SUBJECT: James A. FitzPatrick Nuclear Power Plant
Docket No. 50-333
**Request for Additional Information -
Proposed Changes to the Technical Specifications
Spent Fuel Pool Storage Capacity (JPTS 90-035)**

**RESPONSE TO NRC REQUEST 2 FOR ADDITIONAL INFORMATION
SPENT FUEL POOL STORAGE CAPACITY INCREASE**

HOLTEC REPORT HI-91614
DYNARACK SIMULATIONS TO DEMONSTRATE THE ABILITY
TO PREDICT CLASSICAL NONLINEAR PHENOMENA

FIGURE 2.4

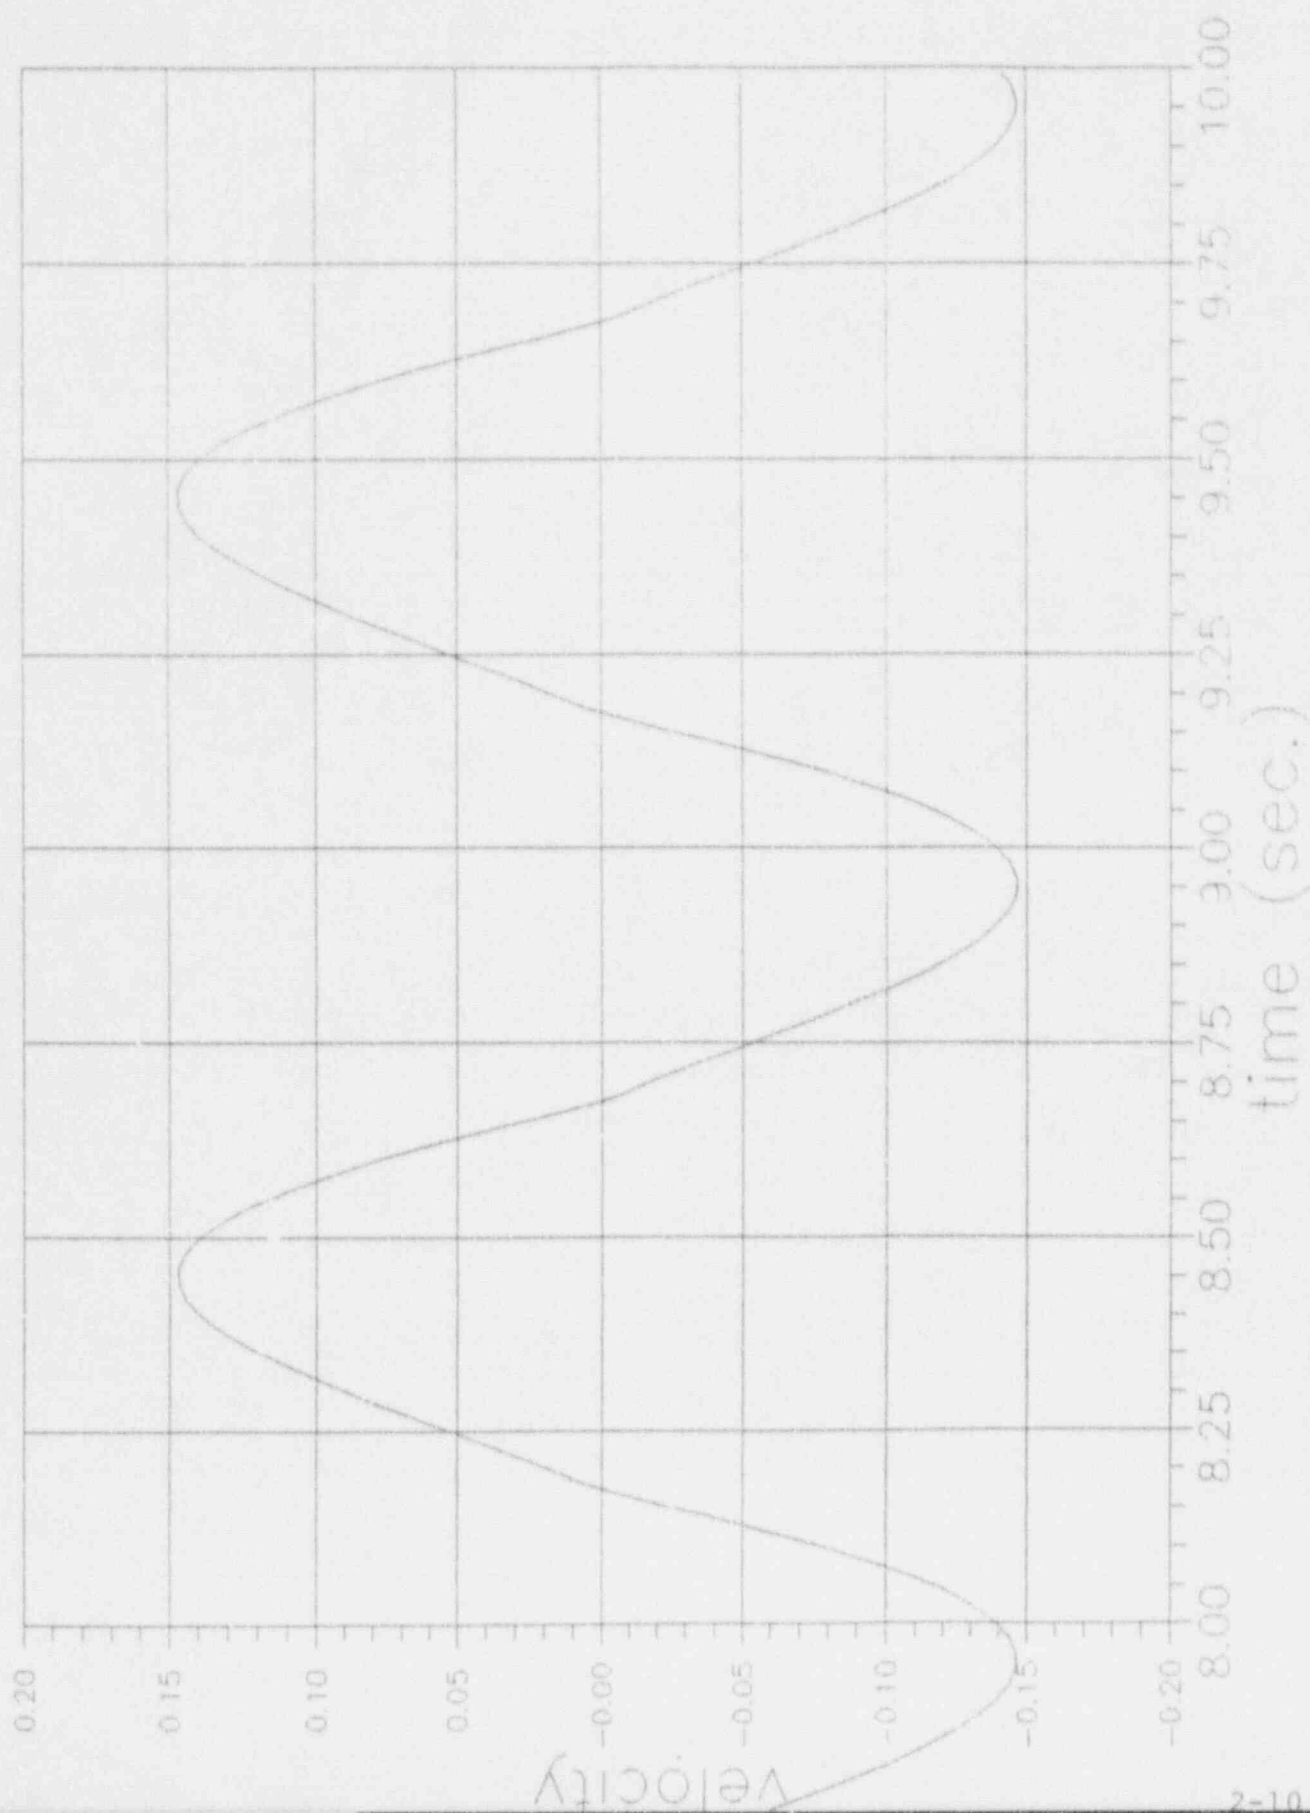
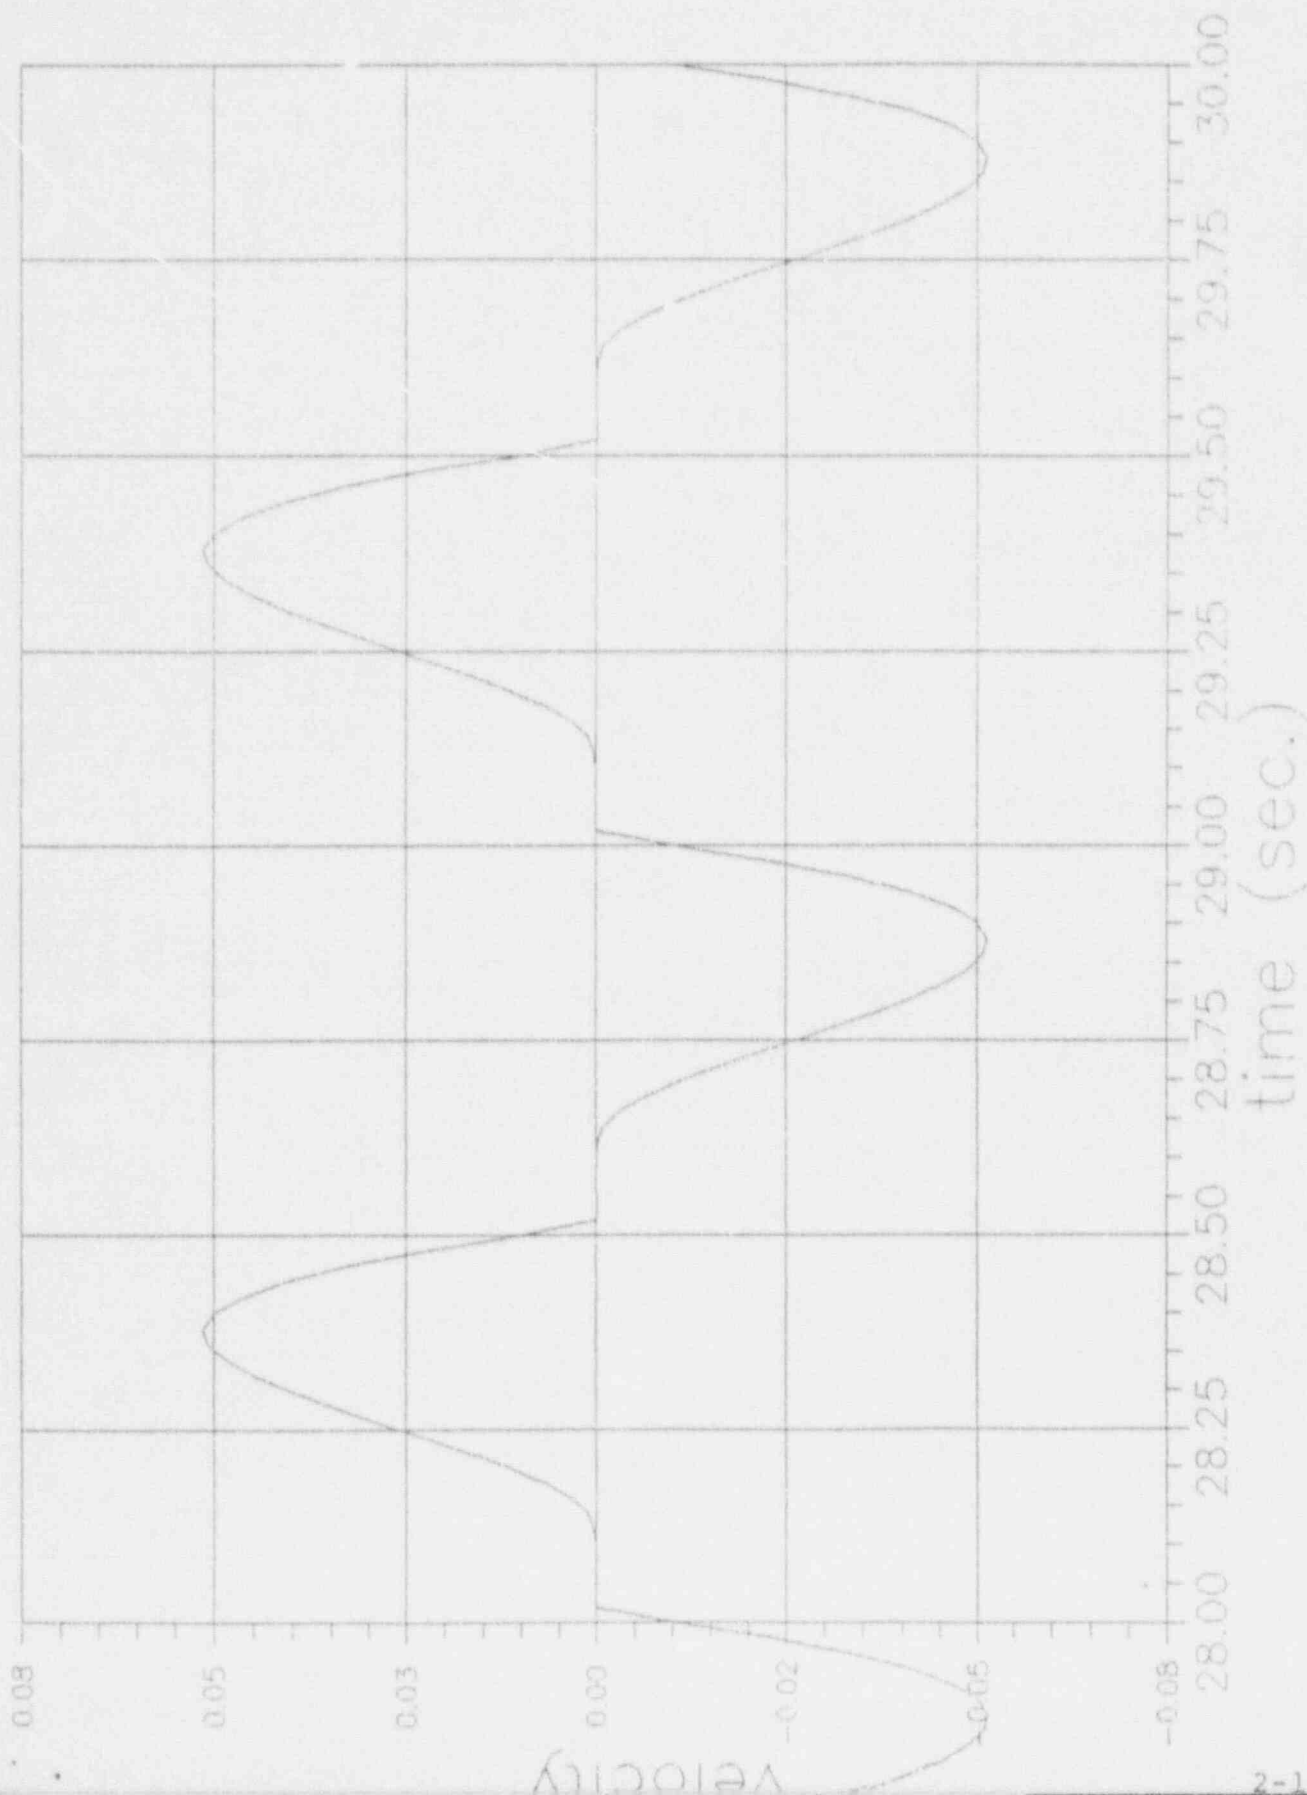
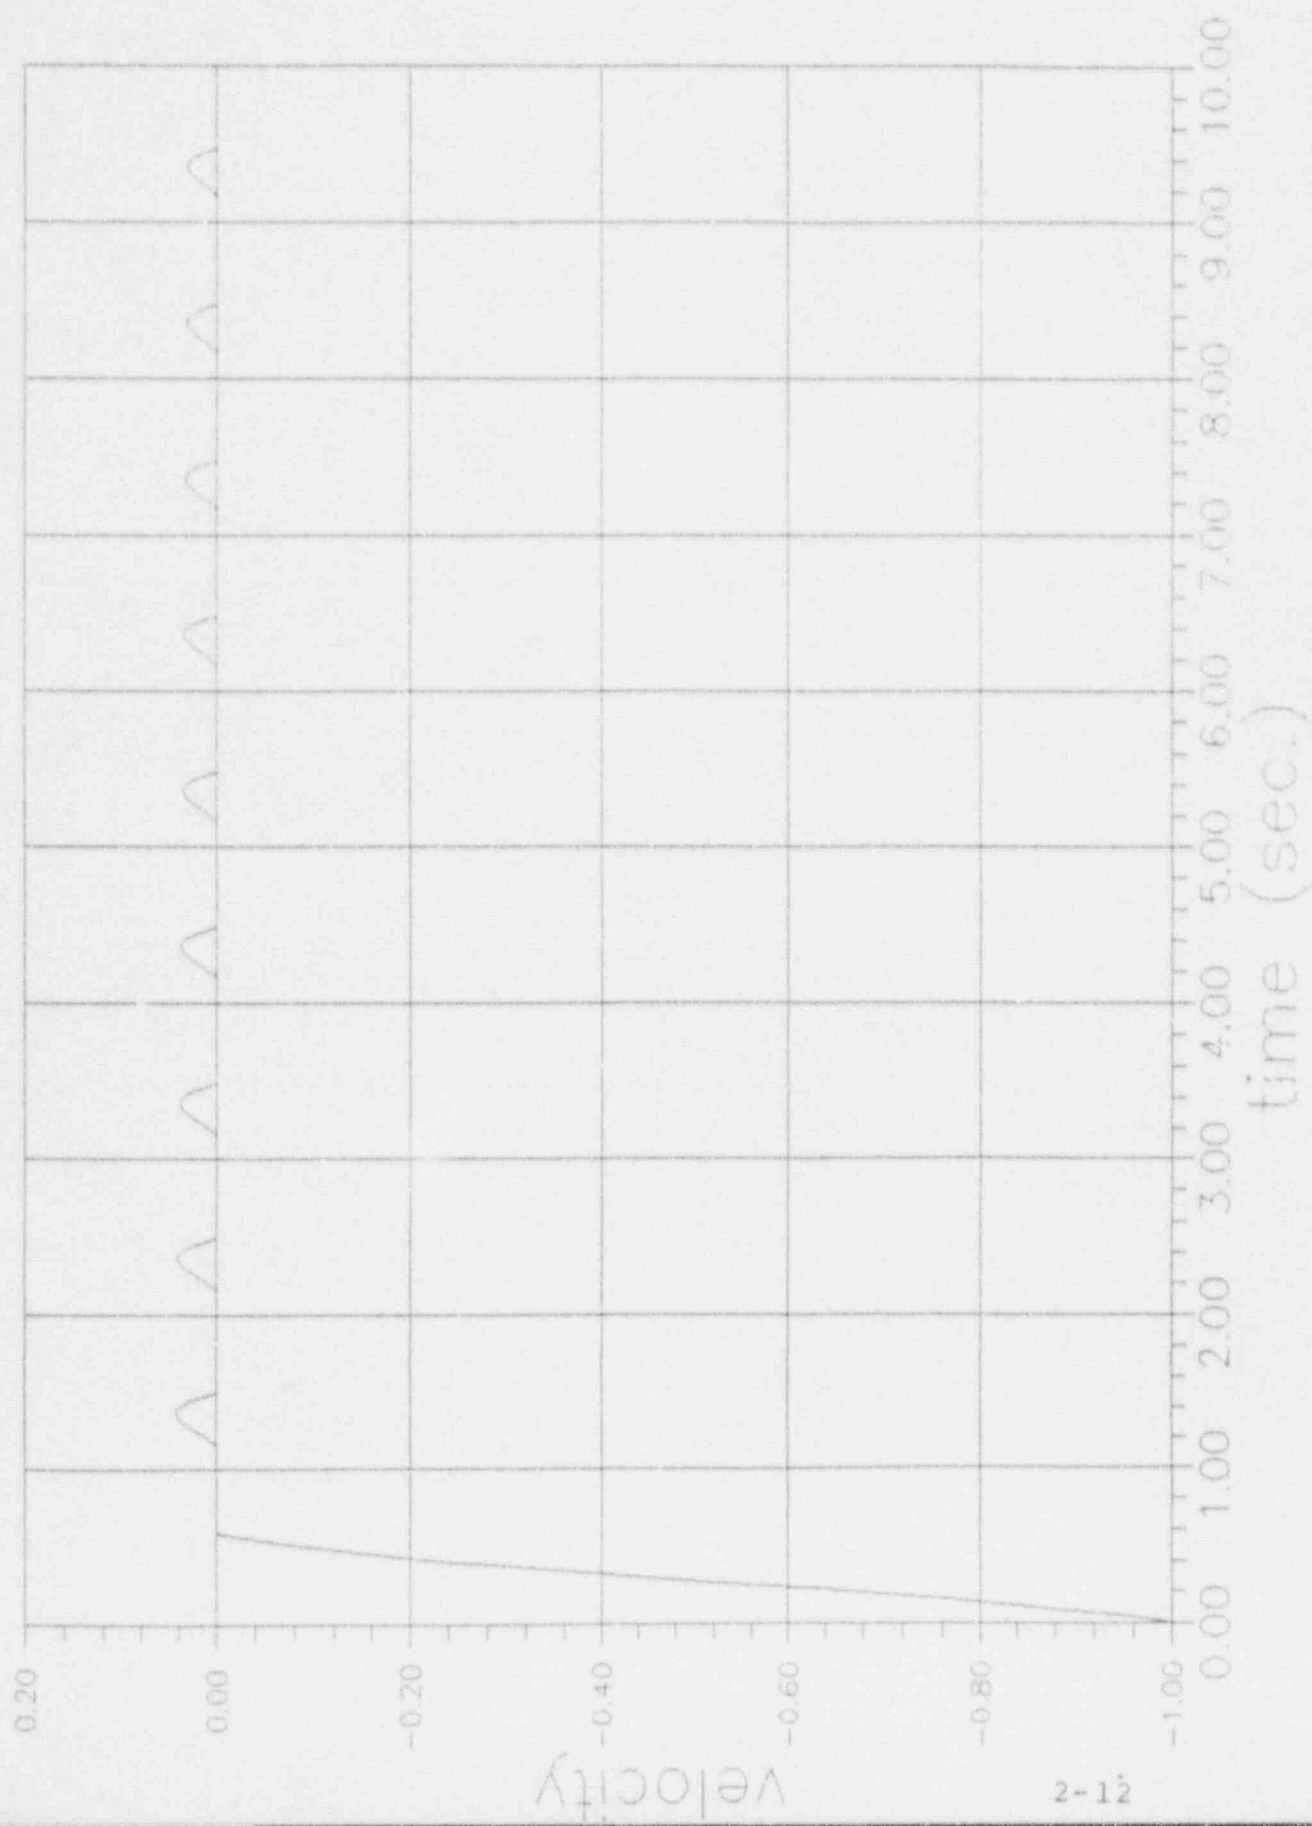
P. 6-15. It is stated that a central difference scheme is used for solution of the governing differential equations. Demonstrate how such a scheme can adequately depict various response phenomena, such as, subharmonic, bifurcation, and instability associated with nonlinear dynamics. Provide a specific example for such demonstration similar to that provided in references (1) and (2). Discuss how error associated with numerical integration is assessed and accounted for in a similar manner as that of reference (3). Also provide verification of the computer results with available experimental data.

We simulate the event for $m = B = 1$, and $R/B = \lambda = .3, .7$, and 1.01 . The friction spring constant (Figure 2.2) is set at $K_f = 1 \times 10^7$ lb./in. to simulate an "infinite" slope. Figures 2.4 - 2.6 show the results for the three values of λ . It is clearly evident that DYNARACK is capable of reproducing the expected phenomena. In Figure 2.6, the small non-zero velocity components subsequent to the initial transient are due to the presence of the finite K_f .
